Model: MPD-READY

Product Bulletin # MPD-002

Replacing DP Transmitter Flange Gasket

Figure 1: DP Transmitter Flange with Aramid gasket (left, replace) and alloy gasket (right)

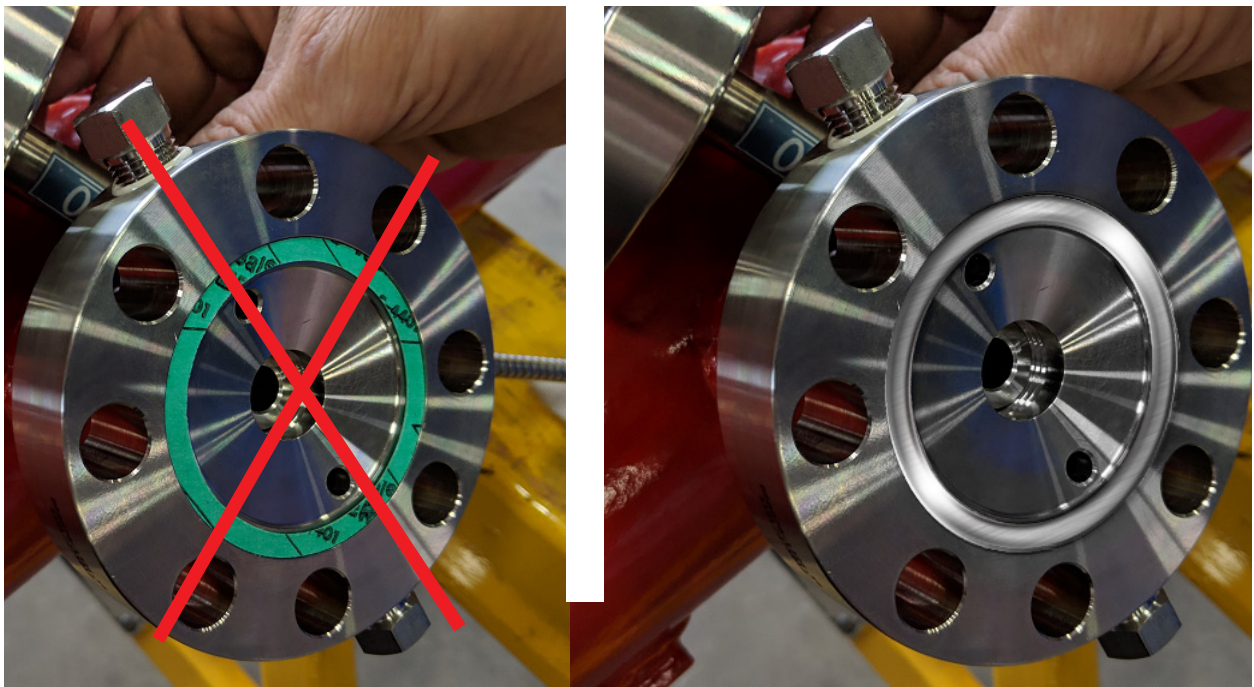
Field tests have revealed that alloy gaskets out-perform the current Aramid gasket on MPD-Ready systems. To avoid critical failure, Canrig recommends replacing the Aramid gasket (a green, fibrous paper-like gasket) with an alloy gasket immediately. This bulletin describes the process to replace the gasket for both flange locations (HI and LO) for one dpDensity spool. Each MPD-READY® system has two spools for a total of 4 flange locations. Contact RigLine 24/7™ Support for more information.

3. Verify Gasket (Item D) is alloy 400 material. Use only Canrig Part Number N11376-04.
4. Straighten out the Capillary (Item 1E) for the HI location and verify that there are no kinks or twists.

Figure 2: Torque Pattern

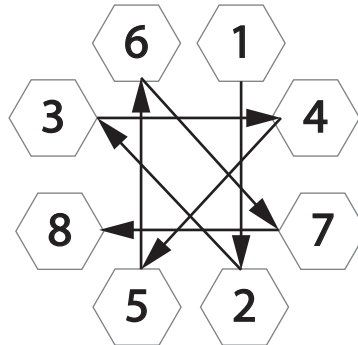
7. Install Bolts (Item 1F) and Nuts (Items 1G) at the HI location and tighten by hand.
8. Use a torque wrench on the Nuts (Items 1G), and tighten the assembly in a cross-pattern to ensure even installation. The Lower Flange Housing includes a small hole designed to facilitate this process and to obtain the required torque level as follows:

- a. Starting at any position, tighten nut to 30 ft-lb, and then move clockwise skipping two nuts each time until all nuts have been tightened.

- b. Check the flange gap for uniformity, and then tighten in the same sequence as in Figure 2 to 70 ft-lb.
 - c. Check the flange gap for uniformity, and then continue to tighten in the same sequence as in Figure 2 to 105 ft-lb.
 - d. Time permitting, wait a minimum of four hours and repeat the torque pattern and torque again to 105 ft-lb to restore any short-term creep/relaxation in the connection.
9. Repeat steps 4 – 8 for the LO location.
 10. Install the Support Cage (Item 7) using suitable hardware. Refer to the next higher level assembly for details.
 11. Position the Pigtail (Item 8) towards the end of the Spool (Item 6). Refer to the next higher level assembly for details.
 12. Zip tie (Item 9), the Pigtail (Item 8) and Capillaries (Item 1E) to the support bar of the Cage (Item 7).
